Re: Task Order: PEER REVIEW OF CH2MHILL'S FEBRUARY 2007 *GROUNDWATER BACKGROUND STUDY REPORT, HINKLEY COMPRESSOR STATION, HINKLEY, CALIFORNIA* PREPARED FOR PACIFIC GAS AND ELECTRIC COMPANY (PG&E)

This memorandum summarizes my review of CH2MHILL's February 2007 *Groundwater Background Study Report, Hinkley Compressor Station, Hinkley, California* (BSP3) prepared for PG&E. In addition to the 7 documents initially furnished by your office, and the 2002 Workplan which you furnished upon request, you also furnished the link to the Lahontan Water Board webpage (to access additional information, including maps since August 2006), so the complete list of reports besides the review report is as follows:

Review Subject: *Groundwater Background Study Report, Hinkley Compressor Station, Hinkley, California (BSP3) CH2MHILL, February 2007.*

Figure 1 Map of Cr(T) and Cr(VI) Sampling Results; Background Study

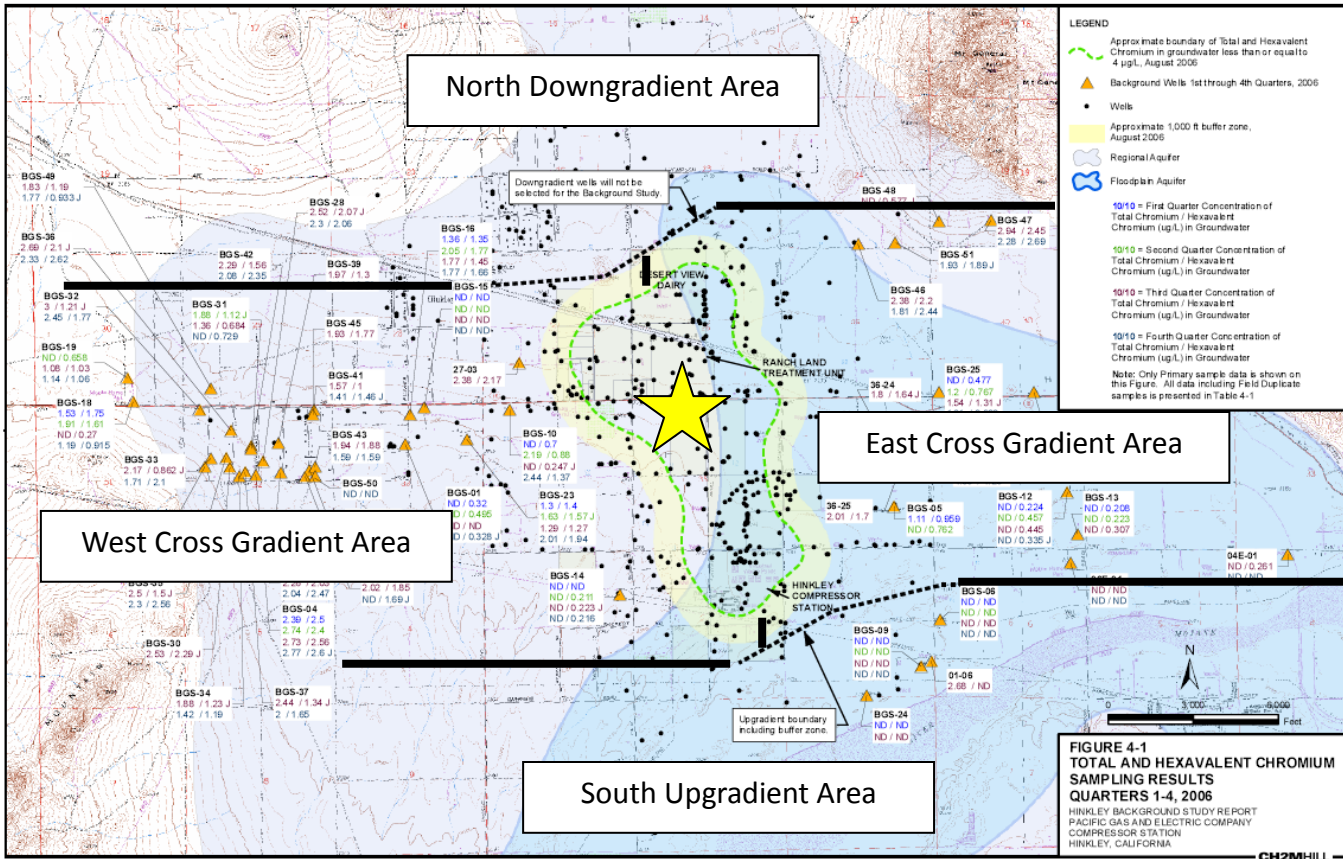
Of the areas shown in **Figure 1**, the South Upgradient Area is the most likely to provide natural or background levels of Cr(T) and Cr(VI). Samples from the Mojave River, although more than one mile from the PG&E facilities, may show less anthropogenic influences for background samples of Cr(T) and Cr(VI) for the region.

In addition to the issues listed above regarding the wells being screened in more than one aquifer, the chosen set of 'background' wells are not located adequately upgradient and outside the range of influence of actively pumping (historically or currently) extraction wells (which could be drawing the Cr(VI) plume in an upgradient direction) to be representative of background conditions. Virtually all of the chosen wells are located in a cross gradient position from the main plume with poorly defined cross gradient Cr(T) and Cr(VI) plume boundaries. As noted, well data should reflect specific aquifer zones, not mixed zones. Given the eight decades of intense agricultural pumping, it is possible that with preferred flow pathways (high permeability zones due to lithologic characteristics or geologic faults (Lockhart) or other potential conduits), some of the Cr(T) and Cr(VI) from the Core Area may have migrated over the past decades toward the east or west into the East Cross Gradient Area or the West Cross Gradient Area, respectively (see **Figure 1**).
